Kimbriki Resource Recovery Project
MP10_0065 MOD 1
Section 75W Modification

On 30 October 2014, the Department received a modification request (MP 10_0065 MOD 1) and supporting Environmental Assessment (EA) from the Proponent to:

Figure 4: Land ownership and Sensitive Receptors

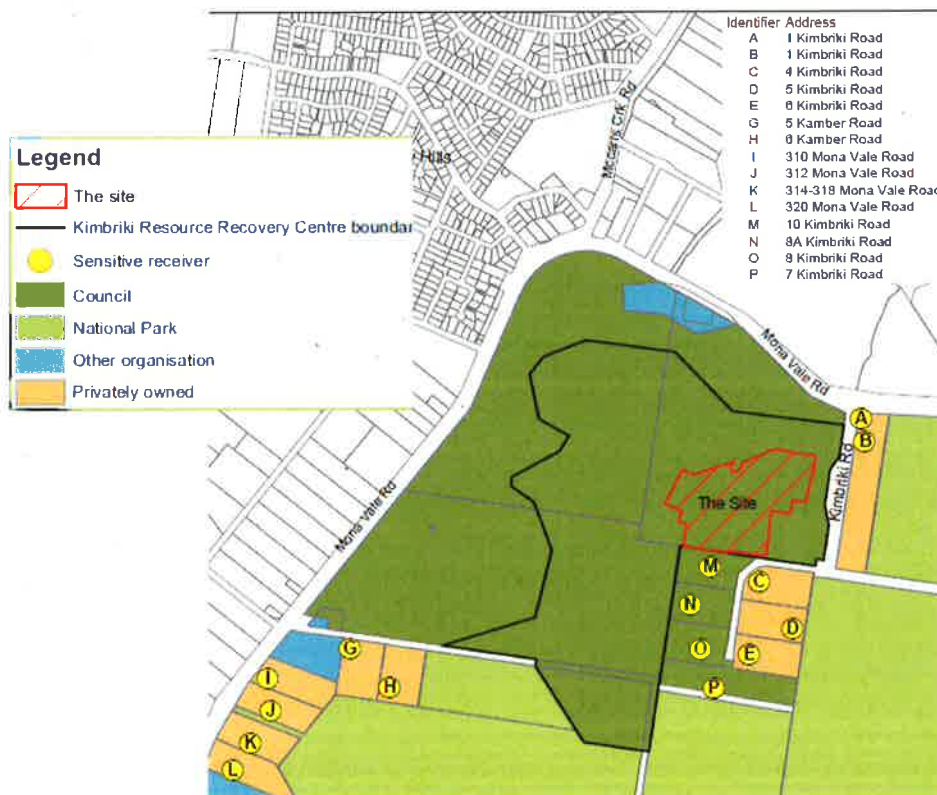
Figure 4 depicts the location of the project site and the nearest sensitive receiver locations.

The daytime noise limits included in the Project Approval are 40dB(A) at receiver B, 38dB(A) at receivers C and D and 37dB(A) at receiver E. These 'receivers' are the closest properties to the Project site that are privately owned. Properties M, N, O and P are Council owned and leased. The Department notes that the project noise limits relate to the project site only (not the project and landfill combined).

The NIA predicted a number of exceedances of the night time construction noise criteria, particularly at sensitive receptors A and B which are located approximately 25 metres (m) and 100m from the intersection (see **Figure 4**). Receptor A, the closest to the work, is predicted to experience up to 68 dB(A) during night time work, which is up to 33 dB(A) above the night time construction noise criteria. Other more distant receivers C, D, E, M, N, O, P are predicted to experience non compliances ranging between 4 and 8 dB(A).

At the Department's request, the Proponent clarified that these night works (and relative noise exceedances) would be undertaken only over a 3 ½ week period. The Department notes that standard noise mitigation measures would be implemented during these works, including:

The Department agrees that the short term construction noise impacts are necessary to enable these roads works to be undertaken quickly and safely. As such, it is recommended that the existing construction hours in Condition 24 of Schedule 4 do not apply to the intersection upgrade works.

Notwithstanding, it is recommended that Condition 27(f) is amended to ensure that the proposed mitigation and management measures described in the Proponent's NIA are implemented during the intersection upgrade works. With these measures in place, the Department's assessment concludes that the short term construction noise impacts are acceptable.

Figure 5: Noise sensitive zones (shaded)

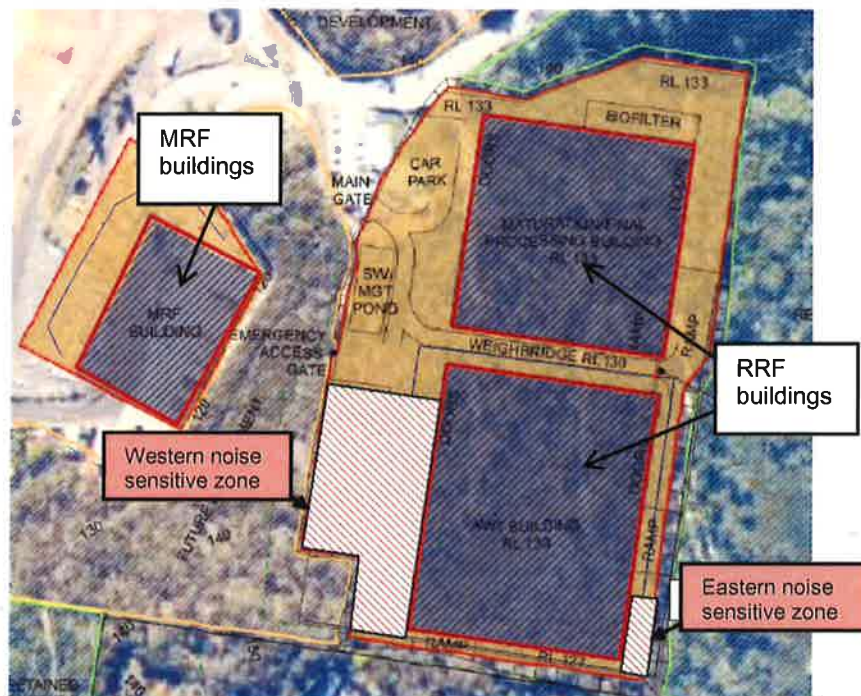
- one (1) FEL operating outside of the MRF during the day;
- two (2) FELs being used outside of the RRF buildings during the day, but only outside of the two (2) "Noise Sensitive Zones" identified on the RRF site (see **Figure 5**); and
- 'periodical' indoor use of additional FELs.

The revised modelling concluded that the Proponent would still be able to comply with the existing noise criteria for the project at surrounding receivers, so long as the FELs avoided the two noise sensitive zones outdoors.

The Proponent also requested that any number of FELs should be permitted *inside* both the RRF and MRF, whilst doors were closed. The Department notes that the periodical use of FELs indoors had been included within the overall noise levels modelled.

The EPA and the Department have carefully considered the Proponent's request. As only periodical FEL use was modelled indoors, it was agreed that more intensive use would require additional modelling. By way of a compromise and to avoid the additional expense and time required to undertake additional modelling, the Department has reached an agreement with the Proponent and the EPA to allow the use of four (4) FELs at the site; that is (3) FELs at the RRF and one (1) FEL at the MRF subject to noise emission validation and monitoring.

In addition, to minimise potential noise and odour impacts, the recommended conditions require the Proponent to ensure that the (3) FELs at the RRF:

- are only operated outside for the purposes of refuelling, repair and maintenance;
- are only operated outside during the day time period;
- do not unreasonably access "Noise Sensitive Zones" that are visually identified at the RRF site; and
- do not have an individual sound power level exceeding 106 dB(A).

Only one FEL may be used during day time operations at the MRF, subject to the Proponent ensuring its individual sound power level is below 106 dB(A).
